Access Compliance Report

Public Rights-of-Way

(Curb Ramps)

Intersection ID: 23917	Main Street: BOSHAM_LN	Cross Street: WHITWORTH_WY	Location: SW
ADA ID: 7139CB214BDF	Ramp Type: Perp	Initial Pass/Fail: Fail	Overall Compliance: No
Severity Score: 12.5			
Codes/Mitigation Info/Possible Solution		Field Measurements/Component Compliance

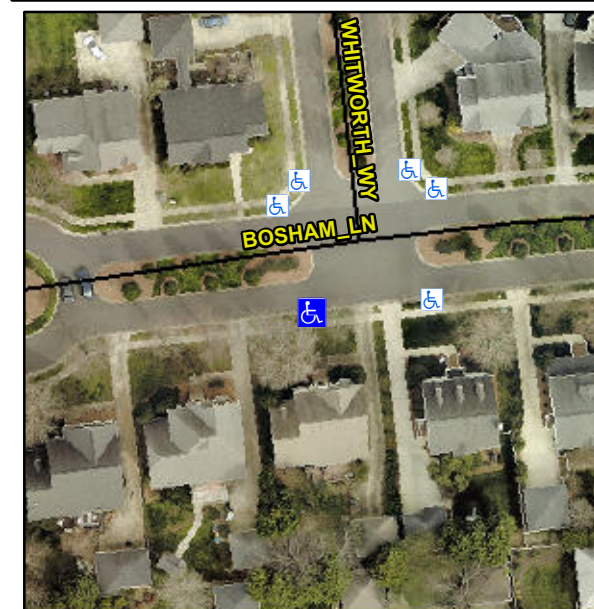
Not Found, R304.5.3

Compliance	Description	Data	Compliance	Description	Data
N/A	Ramp Length (in)	50.0	Yes	Ramp Slope (%)	6.1
Yes	Ramp Width (in)	54.0	No	Ramp XSlope (%)	5.2
N/A	Flare Type LT	N/A	N/A	Flare Type RT	N/A
N/A	Flare Slope LT (%)	N/A	N/A	Flare Slope RT (%)	N/A
N/A	Flare Traversable LT?	N/A	N/A	Flare Traversable RT?	N/A
N/A	Landing Length (in)	N/A	N/A	DWS Provided?	N/A
N/A	Landing Width (in)	N/A	N/A	DWS Contrast?	N/A
N/A	Landing Slope (%)	N/A	N/A	DWS Length (in)	N/A
N/A	Landing X Slope (%)	N/A	N/A	DWS Full Width?	N/A
N/A	Landing Curb? (Y/N)	N/A	N/A	DWS Offset (in)	N/A
N/A	Shared Landing?	N/A			
N/A	Gutter Ponding?	N/A	N/A	Gutter Slope (%)	N/A
N/A	Gutter Lip Ht (in)	N/A	N/A	Gutter X Slope (%)	N/A
N/A	Painted X Walk1?	No	N/A	Painted X Walk2?	N/A
	X Walk 1 Direction	To N		X Walk 2 Direction	N/A
N/A	X Walk 1 Width (in)	N/A	N/A	X Walk 2 Width (in)	N/A
	X Walk 1 Slope (%)	2.9		X Walk 2 Slope (%)	N/A
	X Walk 1 X Slope (%)	3.4		X Walk 2 X Slope (%)	N/A

N/A	Ramp inside XWalk1?	N/A	N/A	Ramp inside XWalk2?	N/A
	Road Slope (%)	N/A	N/A	Clear Space?	N/A
	Road X Slope (%)	N/A	N/A	Clear Space to XWalk (in)	N/A
N/A	Any Obstructions?	N/A	N/A	Storm Grate/Utility Hazard?	N/A
	Obstruction Type			Storm Grate/Utility Type	
		N/A			N/A
			Yes	Surface Condition? (G/P)	Good

Remove & Replace Entire Ramp.
